FINAL Environmental Impact Statement

Union Pacific Resources Company Greater Wamsutter Area II Natural Gas Development Project

ERRATA: MODIFICATIONS, CORRECTIONS, AND ADDITIONS TO THE GREATER WAMSUTTER AREA II DRAFT ENVIRONMENTAL IMPACT STATEMENT

Exhibit 3-8. Sage Grouse Lek Locations.

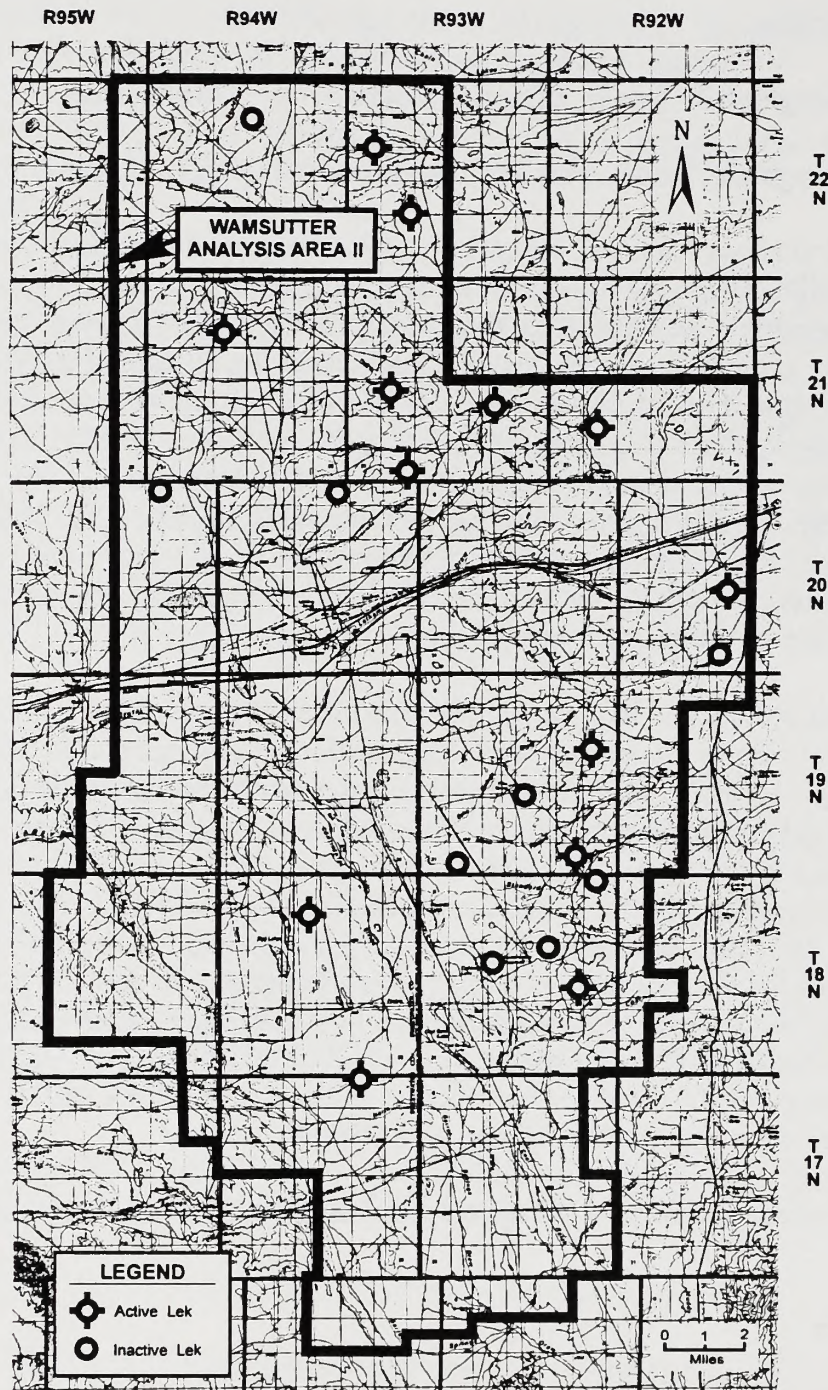
Page 3-63. Replace Exhibit 3-8, "Sage Grouse Lek Locations" with new exhibit on page 1-8 of the FEIS.
